Official Transcript of Proceedings
NUCLEAR REGULATORY COMMISSION

Title: Advisory Committee on Reactor Safeguards
 Plant License Renewal Subcommittee

Date: November 05, 2014

CHAIRMAN SKILLMAN: Good afternoon. Welcome. I'm Gordon Skillman, Chairman of the Plant License Renewal Subcommittee. The subcommittee will review the license renewal application for the Sequoyah Nuclear Plant Units 1 and 2.

RAI Request

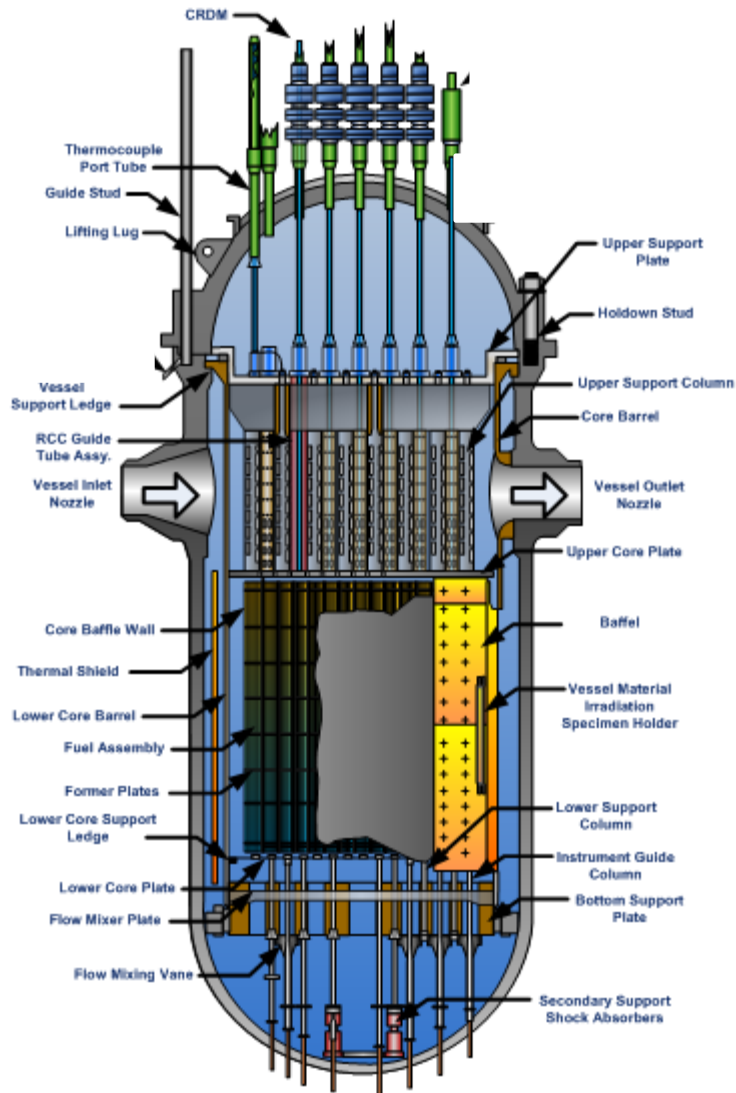
- Provide description of the methodology used to project the 60 year fluence at the Reactor Vessel Internal (RVI) upper core plate (UCP)
- Provide the projected 60 year fluence at the UCP compared to the screening threshold fluence for Irradiation Embrittlement (IE)

- Provided the methodology used for the fluence projections as well as the 60 year projected fluence at the bottom of the UCP
 - Neutron transport method meets RG 1.190
 - Methodology described in NRC approved WCAPs 14040-A and 16083-NP-A
- Provided the basis for the conclusion that MRP-227-A inspection protocols for RVIs remain valid for Sequoyah U1 and U2
- Responses prepared by the **PWROG** and approved by **TVA-SQN**

Upper Core Plate

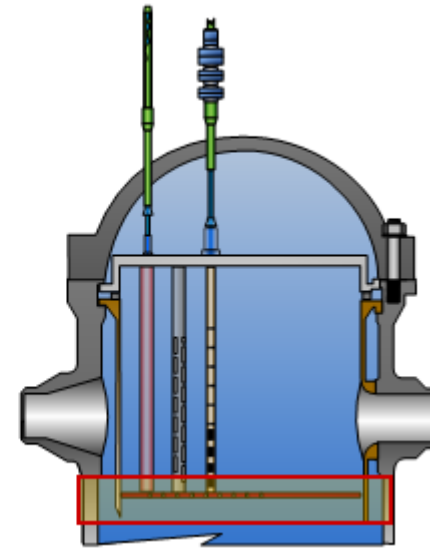
3 The figure on the left is just the overall
4 schematic of our reactor vessel, and the upper core
5 plate is located just above the fuel region. It's
6 about a foot above the fuel.

7 And the figure on the right, it's just a
8 cutaway of the figure on the left. And the upper core
9 plate is in a red box there, so that's the component
10 we're talking about.

17 The RAI really had two issues. The first was
18 to describe the fluence methodology that was used to
19 calculate the fluence at the upper core plate, and the
20 answer to that was pretty straightforward.

4 So the underside, obviously closer to the
5 fuel, more fluence. Now with that being said, being
6 above that threshold doesn't change the overall
7 categorization of the upper core plate.

14 The answer to your question is there are
15 actually no cracking mechanisms that were screened in.
16 The threshold for radiation embrittlement is somewhat
17 lower than the threshold for IASCC within our screening
18 process.

19 So there was no fatigue. There was no IASCC
20 or SCC concern identified in the upper core plant.
21 There was in radiation embrittlement requirement.
